# Service Bulletin

24-020

## Safety Recall: 2020-22 Odyssey Seat Weight Sensor (DTC U3000-49)

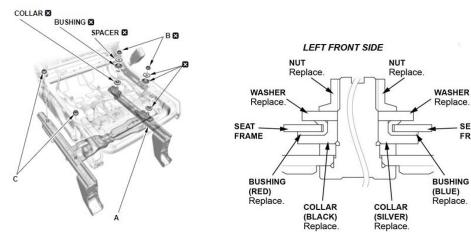
13. Install the front passenger's seat rail/front passenger's weight sensors as an assembly (A) to the seat frame as shown, and loosely tighten the new weight sensor nuts (B) and the mounting nuts (C).

NOTE: The bushings and collars can be identified by their color. Make sure to install the bushings and collars as shown.

14. Tighten weight sensor nuts (A) and the mounting nuts (B) to the specified torque.

NOTE: Tighten the nuts in the numbered sequence shown.
